**Re: London Hydro Inc. (London Hydro)
2017 Distribution Rate Application
OEB Staff Interrogatories
Board File No. EB-2016-0091**

OEB Staff Interrogatories
2017 Cost of Service Rate Application
London Hydro Inc. (London Hydro)
EB-2016-0091
December 9, 2016

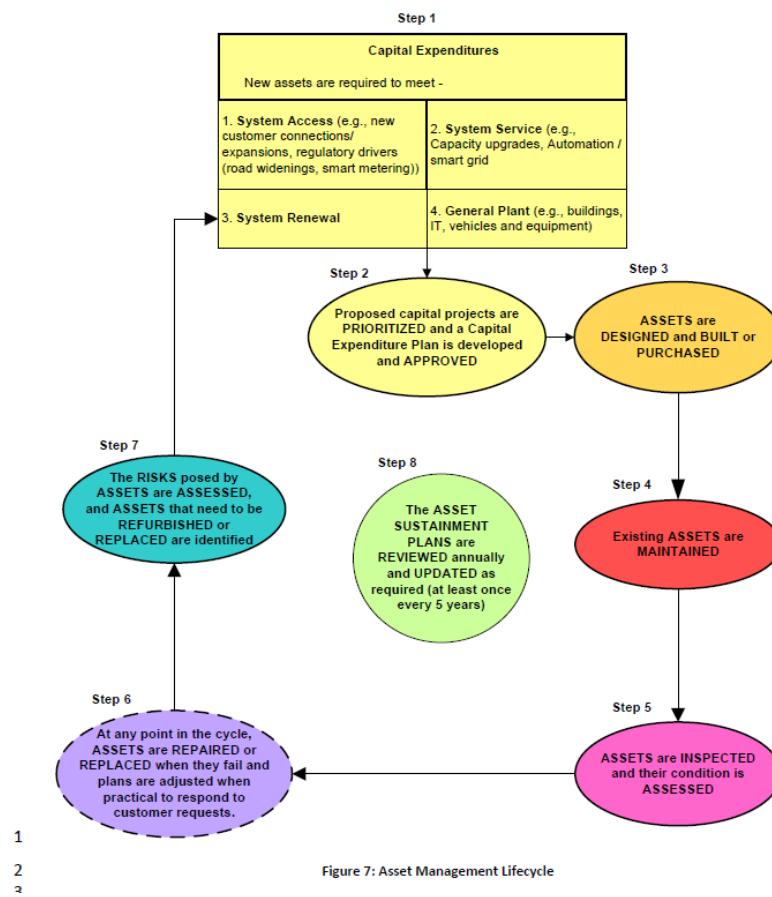
The ongoing process for managing the assets of London Hydro is summarized in the following flowchart (Figure 7, also found in EI-31 page 6).

- In Figure 7 “Asset Management Lifecycle” above, please indicate or explain the connection(s) between Step 8 and Steps 1 to 7.
- In block 3 of Step 1. “System Renewal”, please explain or provide graphical representations of the hierarchical relations and linkages with the three other investment categories (System Access, System Service and General Plant).

- c) Please provide linkages and all detailed steps associated with System Renewal investment category¹. (Attached AM Flowchart² may be used as an example of steps which could be included.)

- d) For Step 5. “ASSETS are INSPECTED and their condition is ASSESSED”. Please explain:
 - i. Does London Hydro have an approved Asset Condition Assessment process and procedures? If so, please provide that process and/or copy of the procedure.

- ii. Are the questions in the inspection forms and the answers designed to be directly useable in Asset Condition Assessments?
 - iii. What are the individual steps to carry out the Asset Condition Assessment, what is the format of the Asset Condition Assessment outcome (e.g. an Asset Condition Report), and based on the assessed condition is the health of the asset indicated?
